URBAN UNION

**Master Use Permit
Recommendation Packet**

Project #3015947

March 26, 2014

SW Corner Perspective

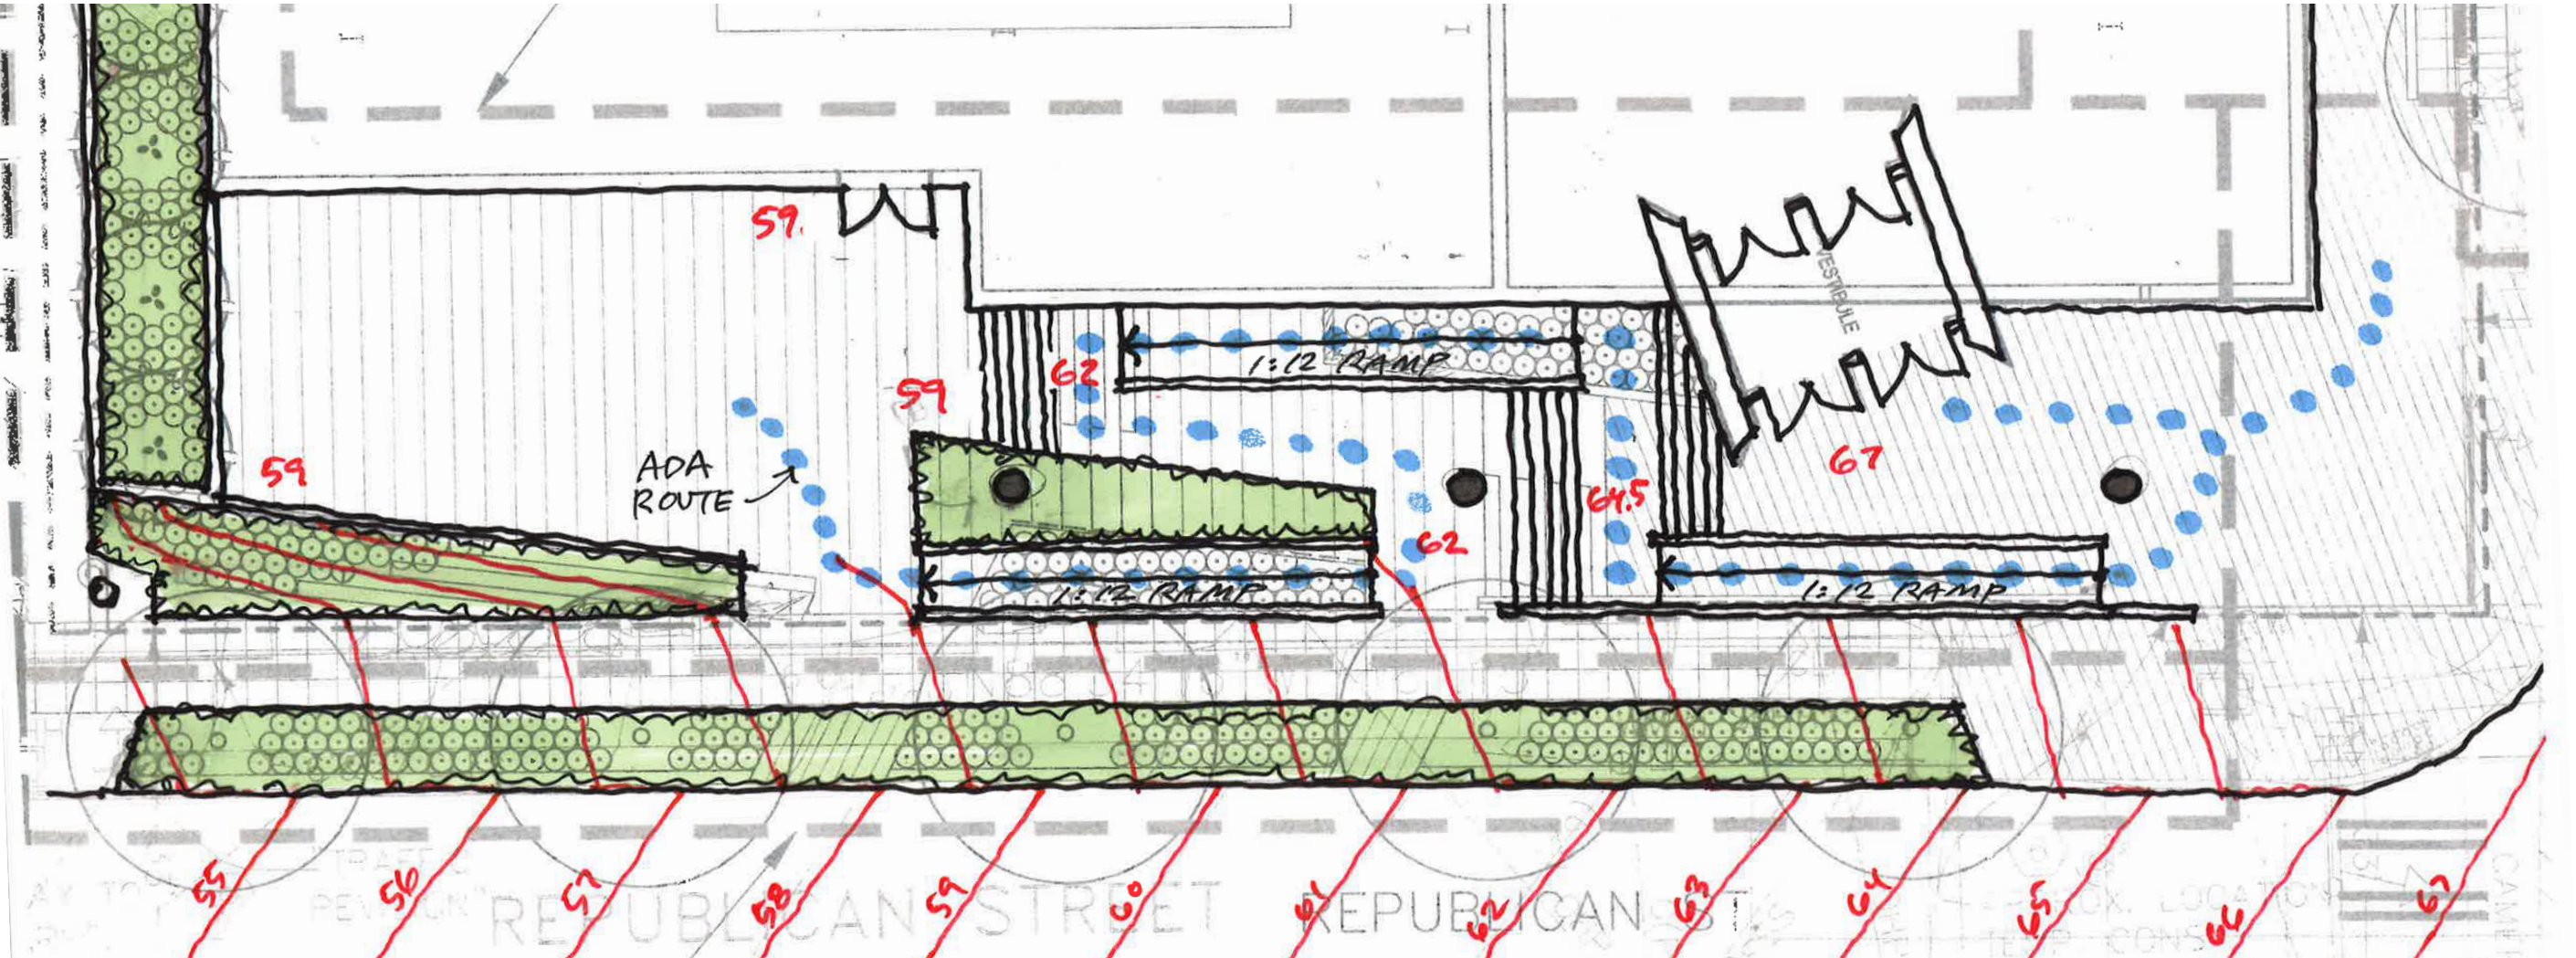
- a. The proposed plaza will provide opportunity for an outdoor restaurant space, but the corner of this plaza includes a 5' retaining wall. The edge of the plaza needs to be treated to create a better visual transition to the sidewalk. Possible strategies include landscaping, water features, boulders, etc. (A-2, C-3, D-1, D-2, D-3, E-2)

- c. The retaining wall and any handrails on the south edge of the plaza should be treated for human scale and visual interest. (C-3, D-2, D-3)

- d. The southwest corner of the site should be designed to provide clear sight lines between pedestrians and vehicles at the alley intersection. (D-7, D-8)

RESPONSE: The wall at the southwest corner of the plaza has been moved 8 feet north away from the sidewalk with a landscape transition zone, reducing its impact from the sidewalk. Angled steps create a wider, friendlier entry allowing more visibility into the plaza and a more natural transition from the sidewalk. Refer to the landscape plan, sheet L1.00 and the Republican Street perspective located on page 6 of the MUP supplemental package.

RESPONSE: The handrail will be an open metal railing, allowing visibility into the plaza. As noted in item 1a above, the westerly portion of the retaining wall has been moved to the north, setting back from the sidewalk, with landscaping and angled steps. The mid-block walls have been reduced in height by introducing an intermediate plaza. The retaining walls will be integrated with the landscape to reduce their visual impact.

RESPONSE: As noted in item 1a, the southwest corner of the plaza has been moved north away from the sidewalk 8 feet, which opens up a clear sight line from sidewalk into the alley. Low planting will create a buffer, and allow visibility for both pedestrians and cars. This widened area will act as a node for pedestrians walking on Republican Street.

ADA Ramp Study

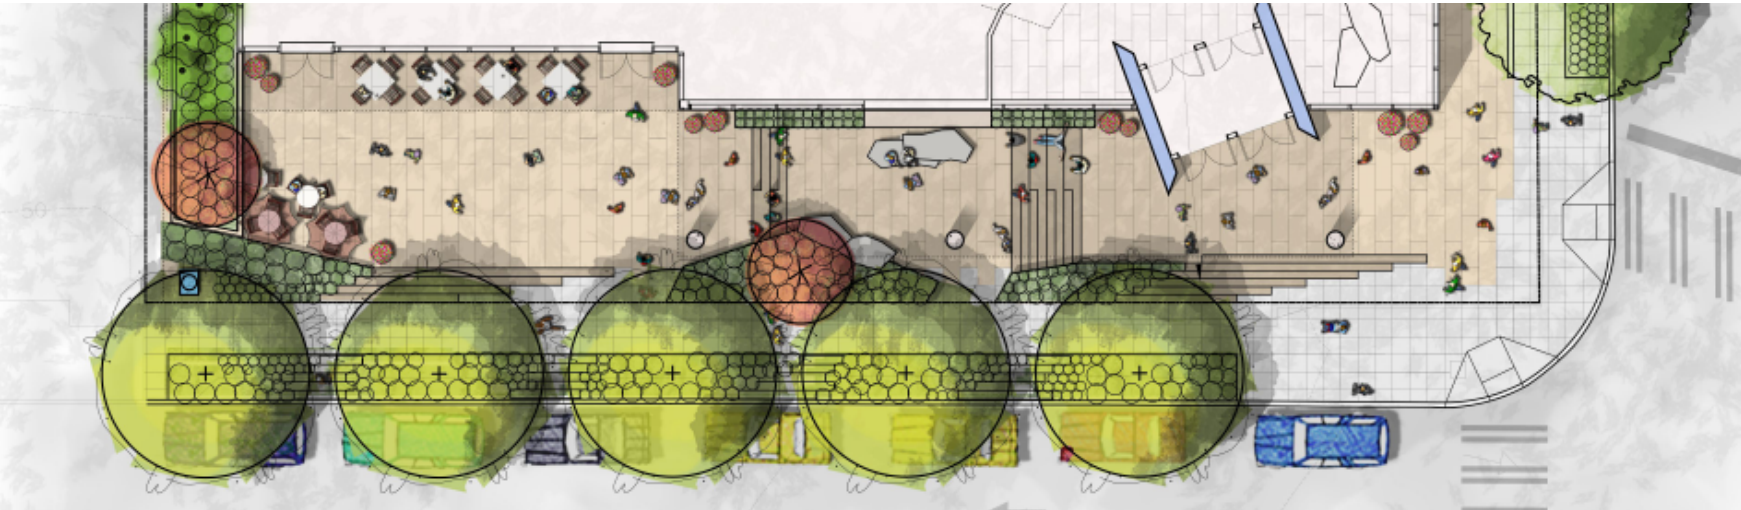
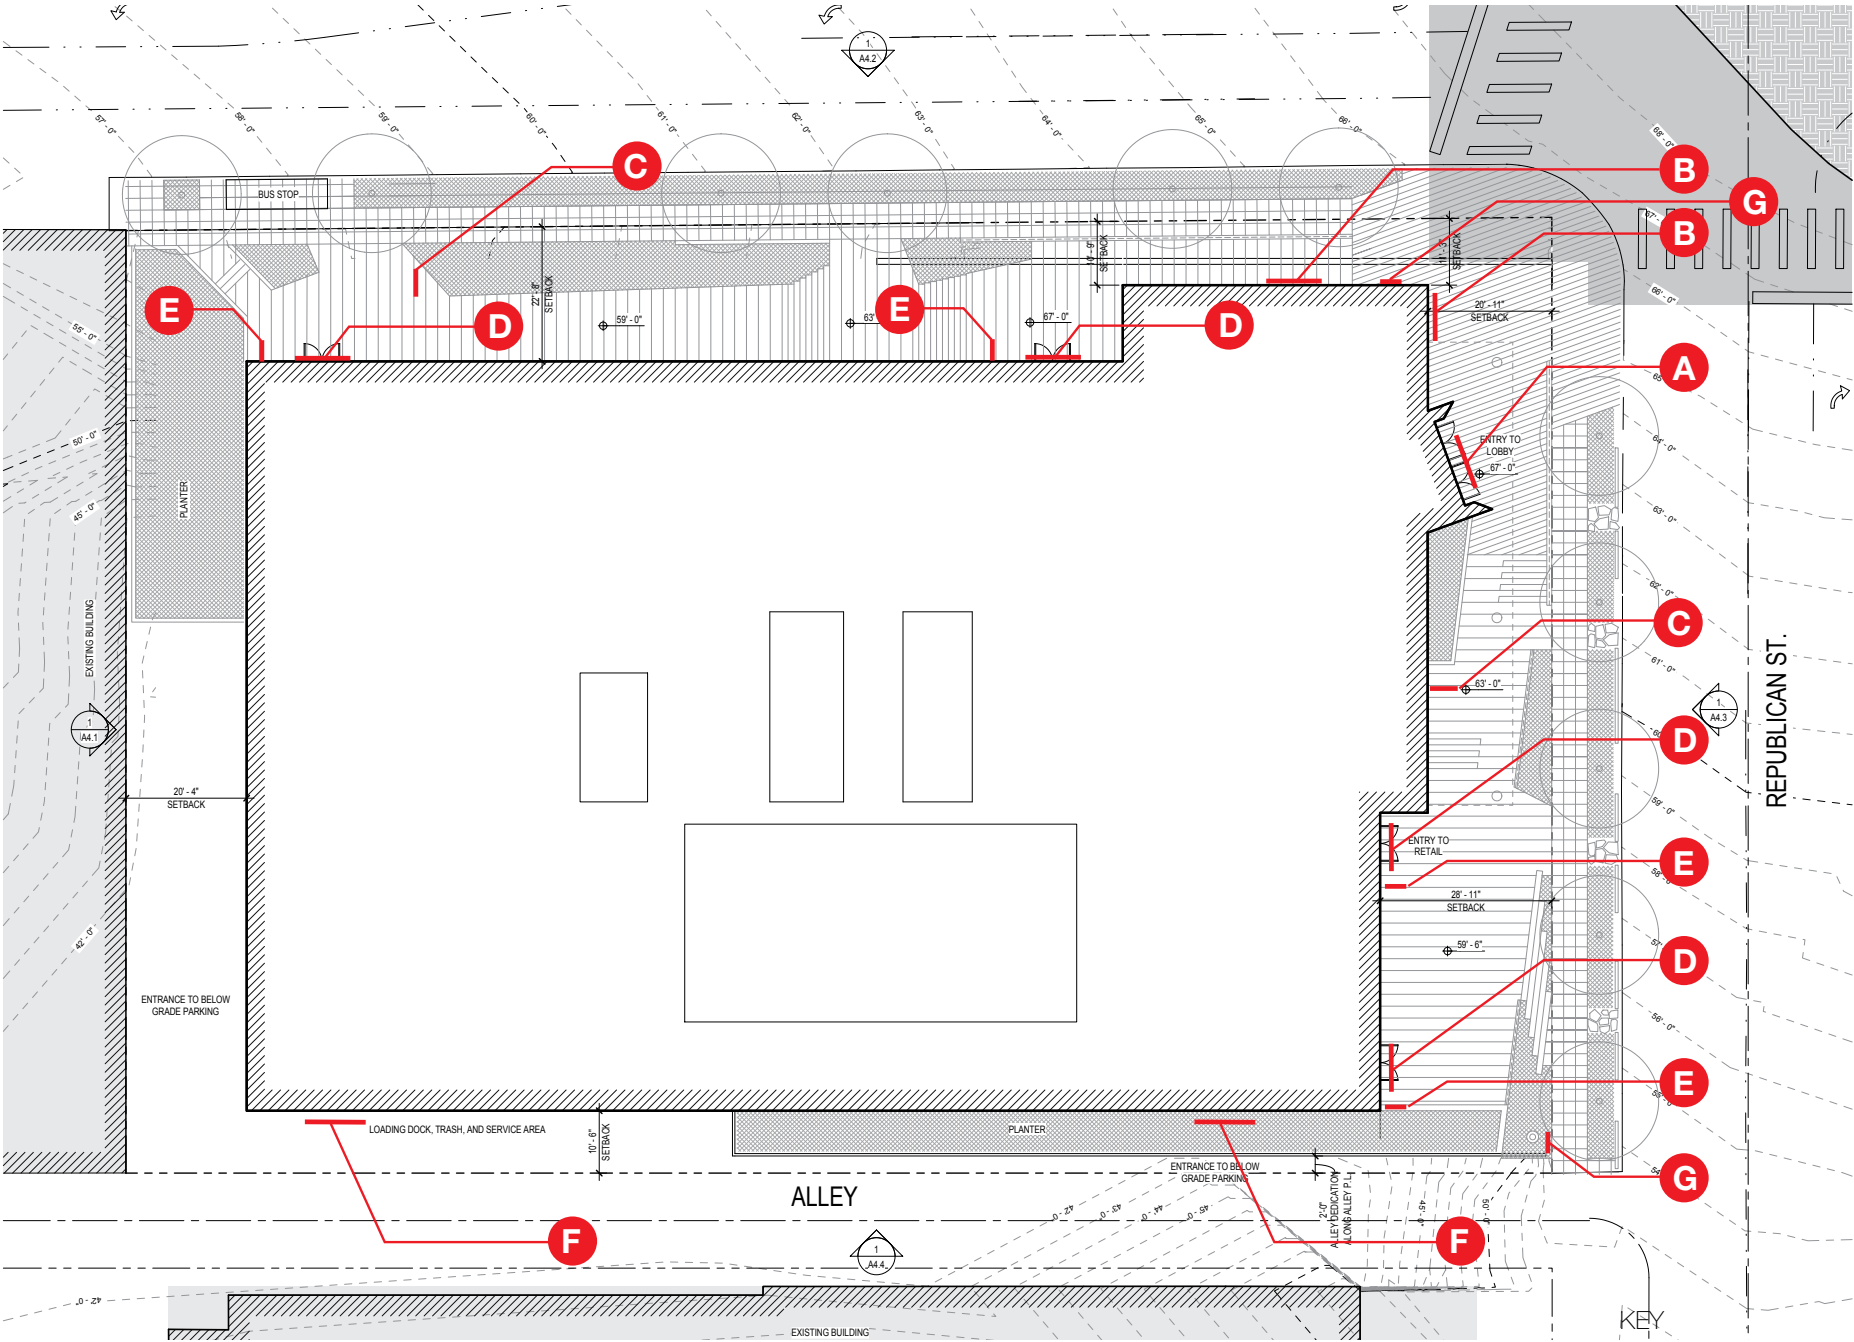
- b. If possible, an ADA ramp/stair system should be provided between the plaza and the sidewalk on Republican St. (A-1, A-2, A-4)

RESPONSE: An ADA ramp was investigated, but the length of the ramp alone would be between 96 feet and 160 feet not counting intermediate landings, significantly reducing the available plaza space, and creating a very complicated switchback pathway from upper to lower plaza. The introduction of a feasible ADA ramp and required landings would create a redundant pathway of virtually the same slope as the adjoining sidewalk (8.0 % vs. 8.1%) that would take up nearly half of the Republican frontage, usurping most of the usable space between the sidewalk and the building along its length. As an alternative, we are proposing an intermediate plaza level that connects to the sidewalk, creating an extra landing area and entry point, and reducing the distance traveled between plazas by half.

SIGNAGE ELEVATIONS

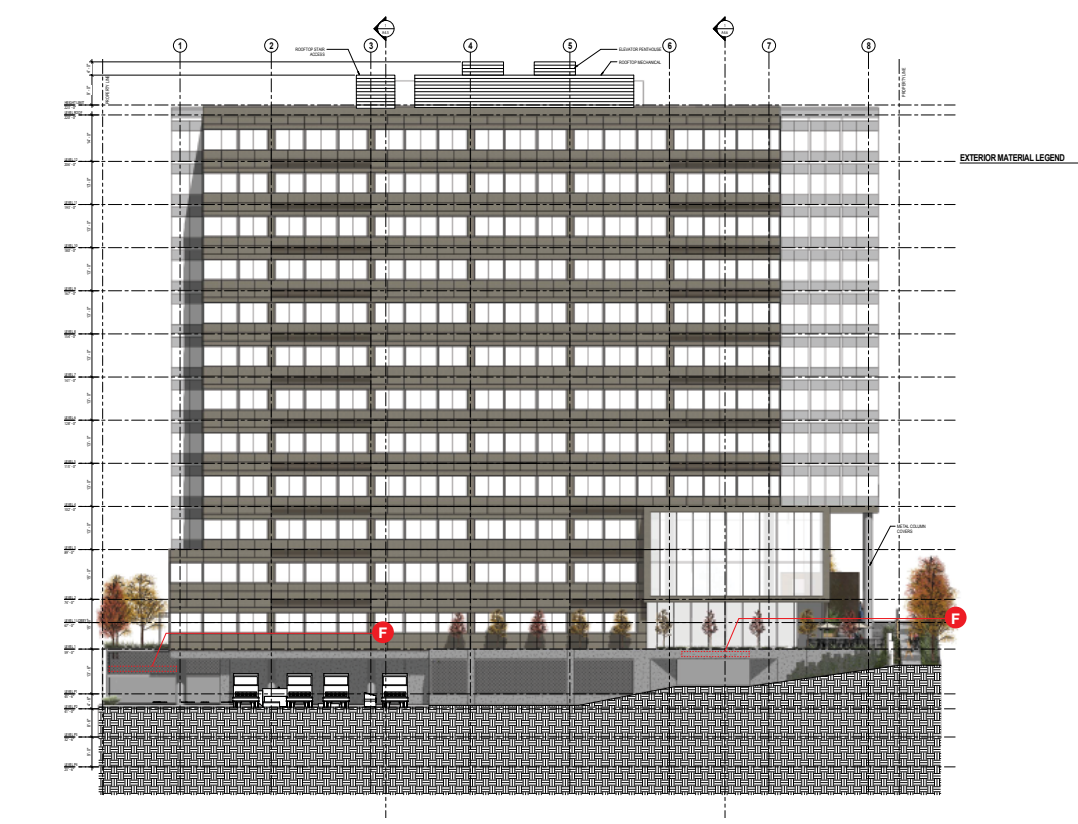
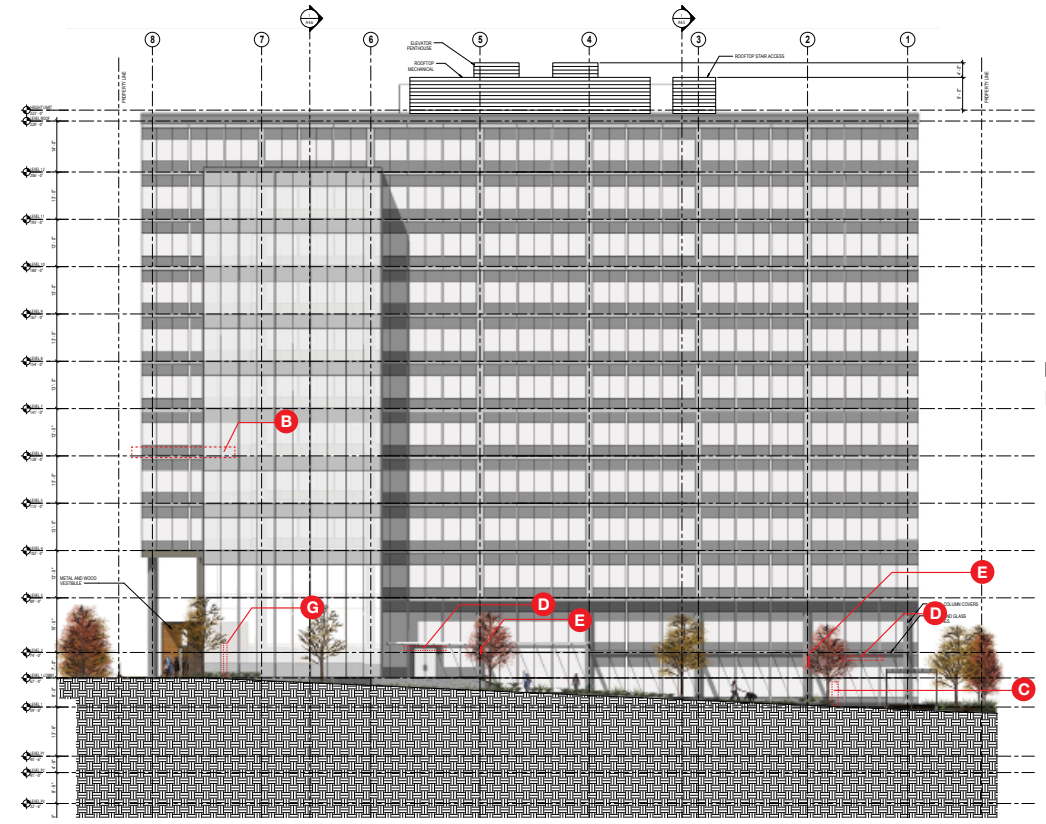
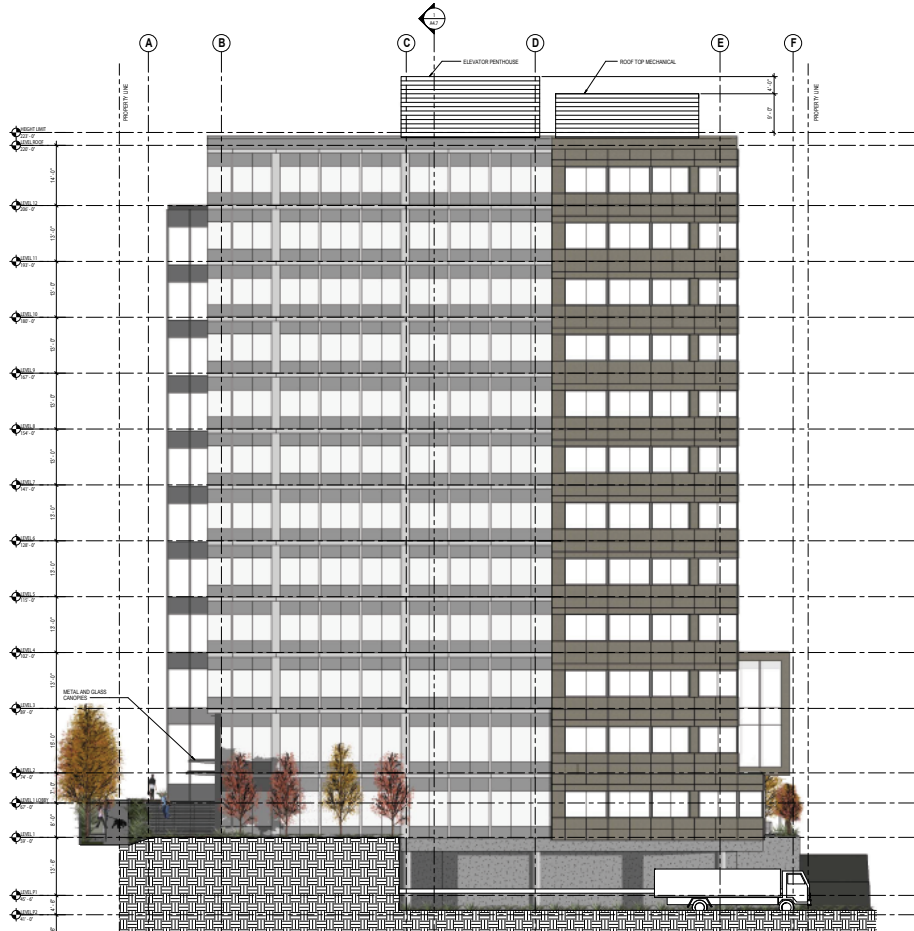
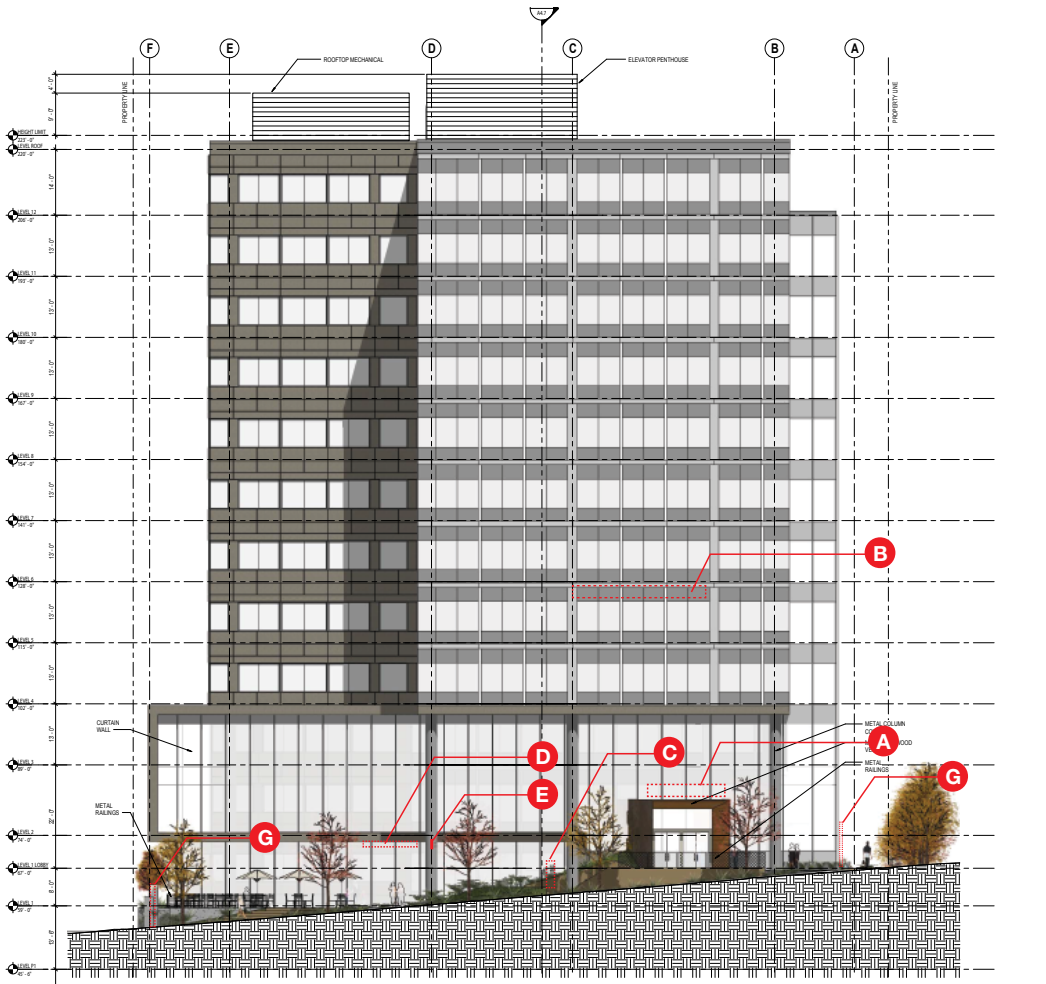
e. Signage opportunities should be provided on the façade, especially near the south-west corner (to avoid the need for sandwich boards in the sidewalk). (D-9)

RESPONSE: See the attached Architectural Graphics Package prepared by Olive Design, illustrating opportunities for building mounted and free standing signage for building identification, tenant signage, and parking garage entries. Signage will be oriented for both pedestrian and vehicular orientation as viewed from Republican Street and Fairview Avenue as well as the alley.
